## **Charlotte Historic District Commission**

Staff Review HDC 2014-069

# Application for a Certificate of Appropriateness

**PROPERTY ADDRESS:** 1400 Pecan Avenue

NEW REAR ELEVATION

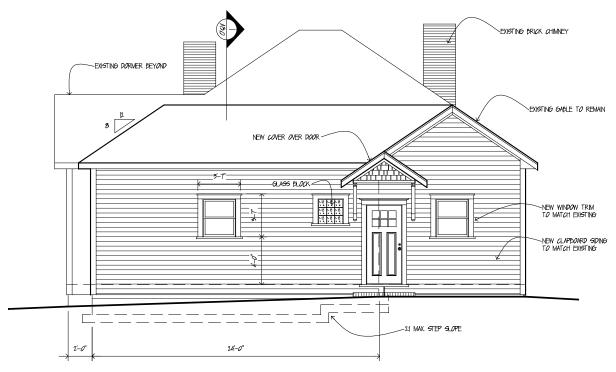
The proposal meets the guidelines for additions.
